Docket Item #10
SUBDIVISION #2006-0010

Planning Commission Meeting
March 6, 2007

ISSUE: Consideration of a request to subdivide the subject property into two lots.

LOCATION: 112 East Glebe Road

Figure 2

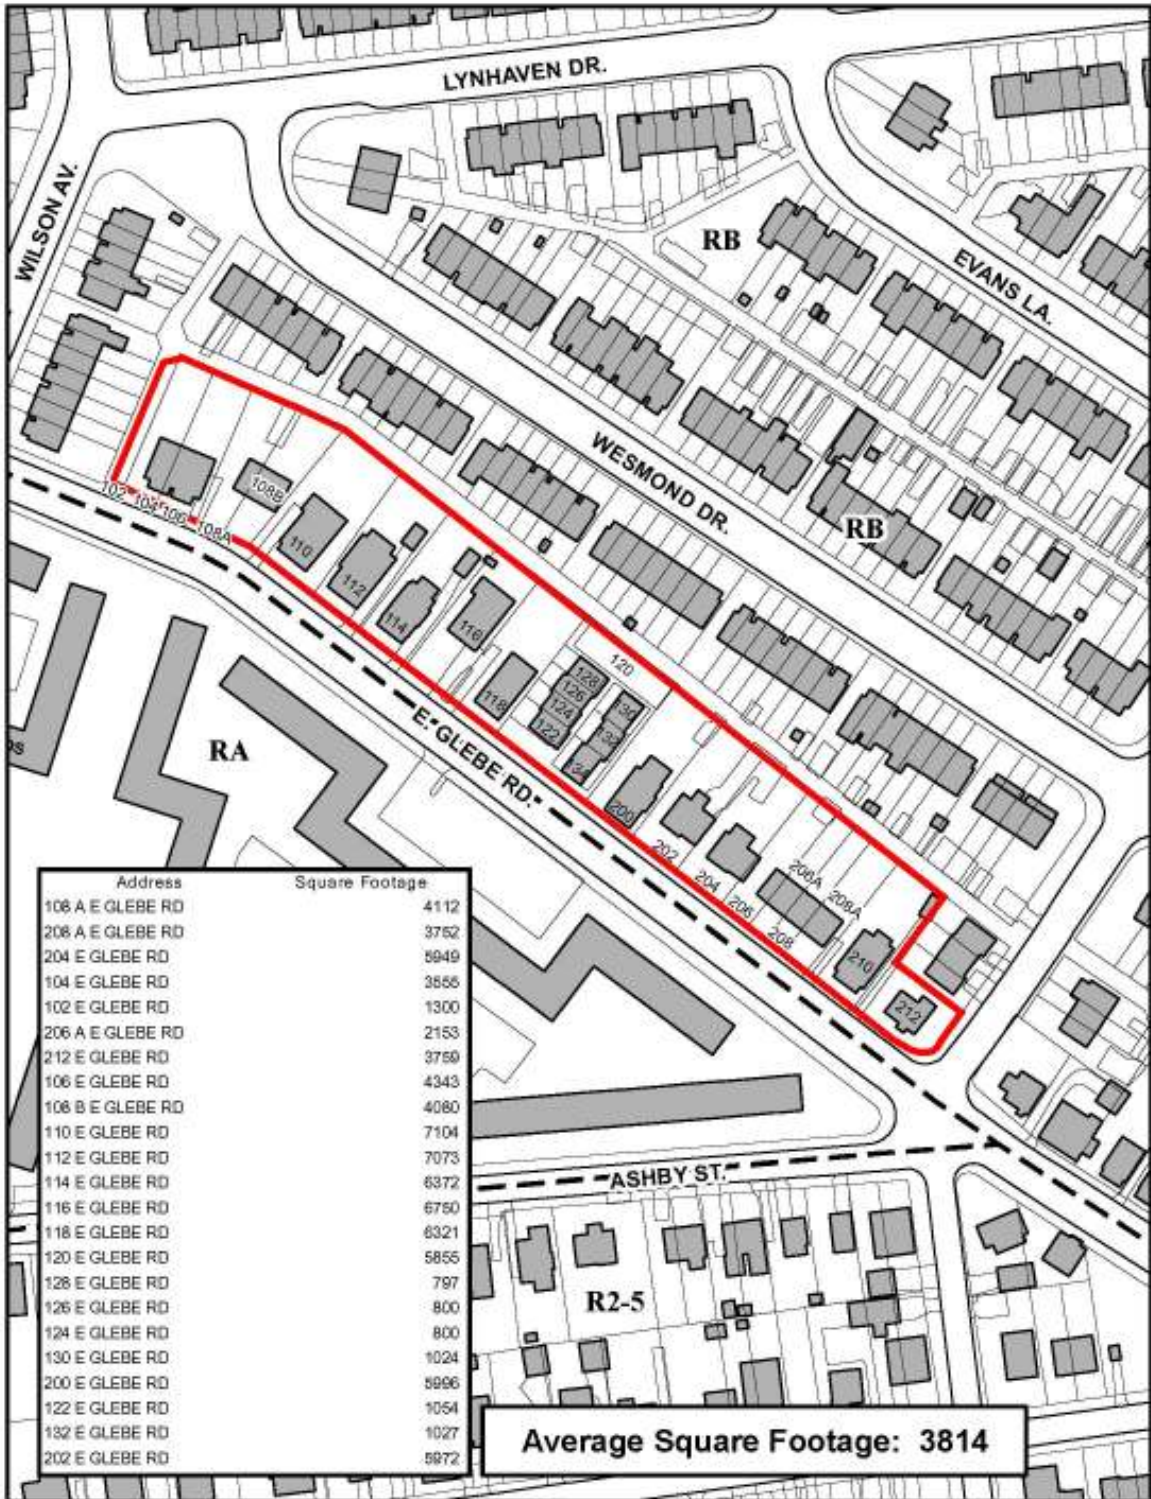
Staff conducted an analysis of the block containing the subject property. The blockface with frontage on East Glebe Road has lots with a range of sizes between 797 square feet and 7,104 square feet with an average of 3,814 square feet (see Figure 1). The remainder of the block fronts on Wilson Avenue, Wesmond Drive and Montrose Avenue and consists of significantly smaller lots, averaging 1,815 square feet (see Figure 2).
